DEVELOPMENT REVIEW COMMITTEE (DRC) COMMENT REPORT

PROJECT NAME: Fort Lauderdale Pickleball

CASE NUMBER: UDP-S23008

REQUEST: Site Plan Level II Review: Outdoor Public Recreational Facility including 45 Courts, 4,242 square feet Pro Shop, 3,950 square feet Center Court Building and Concessions

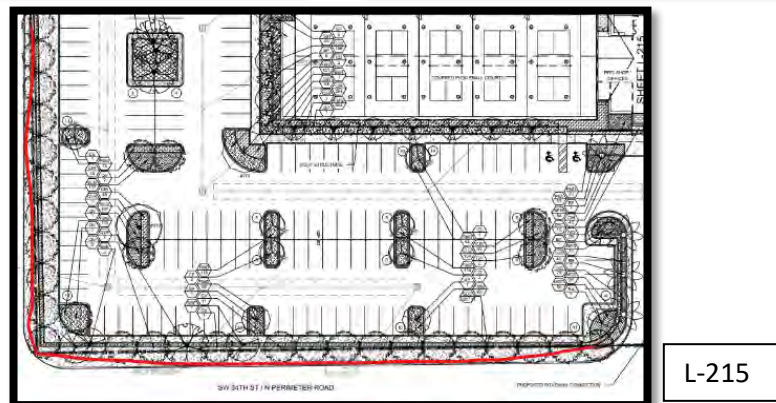
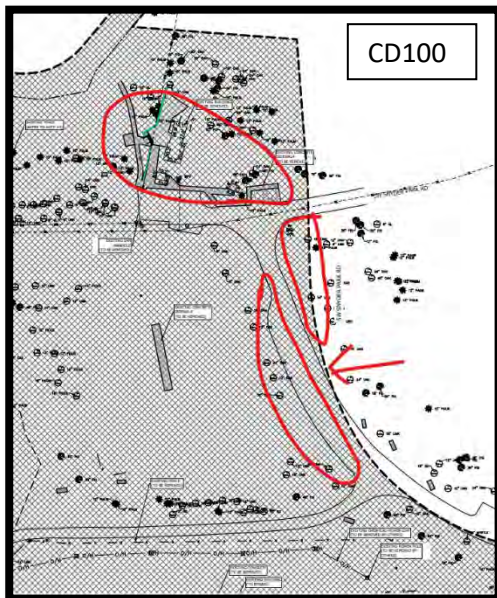
19. Peninsular and island landscape areas placed intermittently every ten (10) parking spaces are not necessary when the landscape area adjacent to the front of the parking spaces is fifteen (15) feet or more in depth. Section 47-21.9.A.4.e. Please provide additional tree islands and shade trees within the VUA.
20. Additional comments may be forthcoming after next review of new plans and written comment responses.

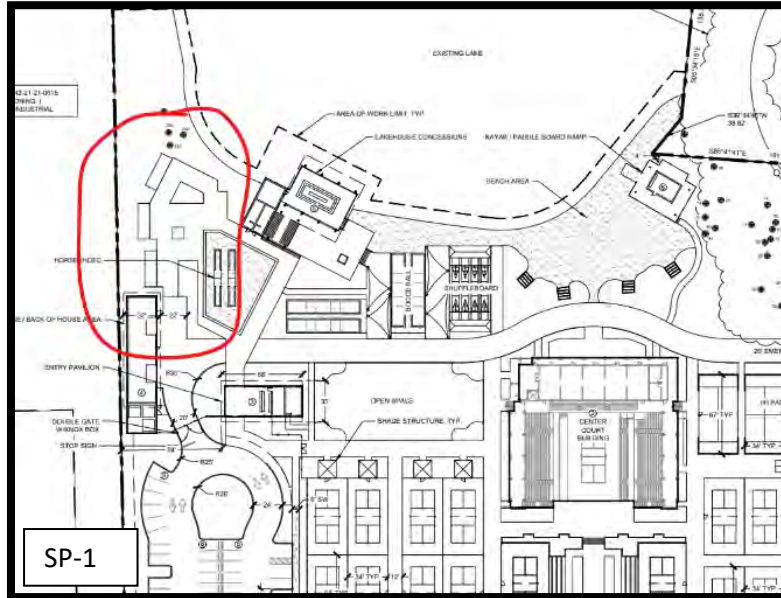
2. Sheet SP1 Site Data indicates a 7.90-acre lake, however just the eastern edge of the lake is included in this project. Clarify this calculation.
3. Sheet SP1 Legend does not include key for bold line. What does this represent? If this is meant to illustrate the limit of work line, this must truly represent the limit of work. For example, CD100 Demolition Plan (below) illustrates demolition of will remove approximately 20 existing parking spaces along W edge of road and reconfigure the road radii; remove handicapped parking and structures along NE area. This hatched area shown with red arrow below does not appear to coordinate with 'limit of work' line on ALL sheets. Additionally, it does not appear that grading or replanting in these demolition areas are proposed (see below) Likewise, the ROW along 34th Street and 9th Ave does not appear to be included in work are, landscape improvements are proposed (see below). All sheets must have accurate 'Limit of Work' line illustrated and labeled.

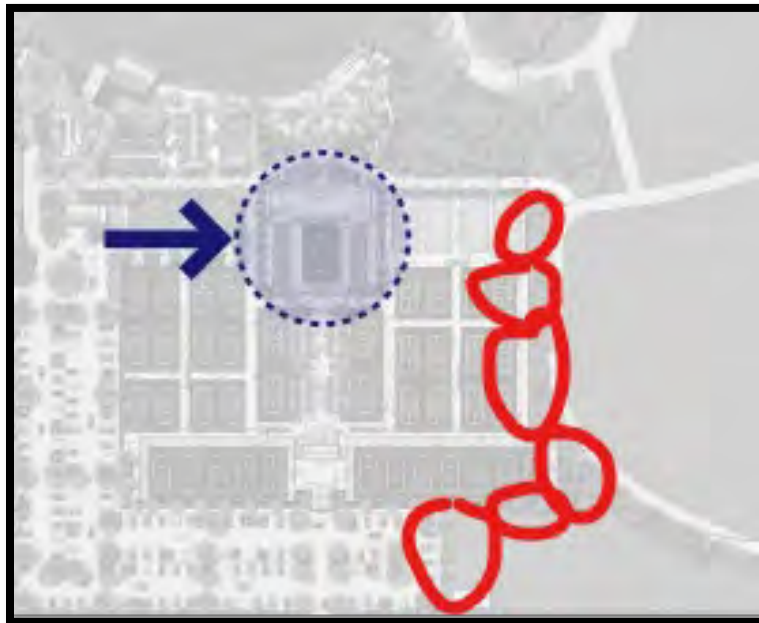
9. Provide details of E standard pickle ball courts (in red below) and how they relate to the adjacent park use (is it fenced so it cannot be accessed from park, are there building walls at east perimeter of courts, how tall is berm, etc.). For example, Sheet L-216 illustrates containers along E of courts, but this does not appear to be specified anywhere on-site plans.

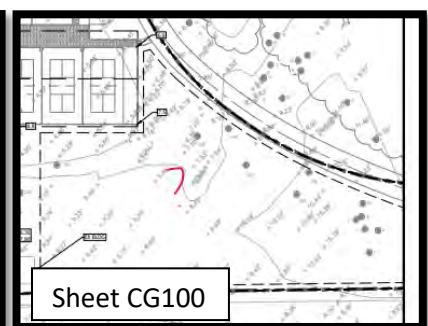
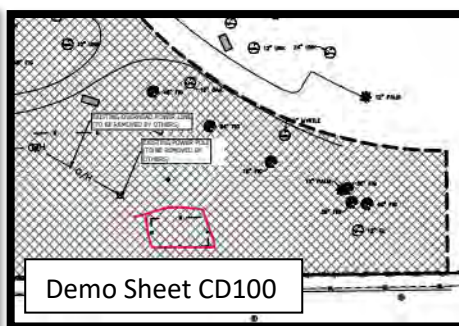
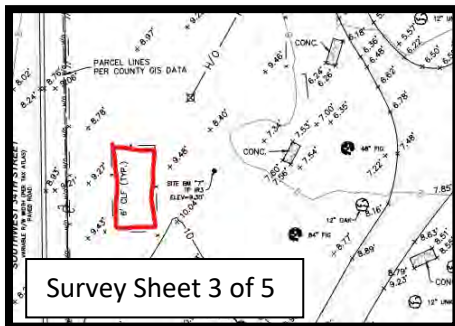
- 10. In relation to Comment 9, provide proposed details for existing Train Depot structure.
- 11. In relation to Comment 9, provide details for the perimeter along 34th Street. Is there a fence or wall? If so, be aware of ULDR Section 47-19.5 in respect to fence/wall opacity and required setbacks and required landscaping within the property line. Such setbacks and landscape requirements are not clear on Sheet SP1, L-215 & L-216.
- 12. Survey Sheet 3 of 5 – illustrates City Nursery Structure and Demo Sheet does not state its removal, however, Civil Sheet CG100 does not illustrate it is remaining. Provide detail illustrating where City Nursery structure is proposed to be relocated.
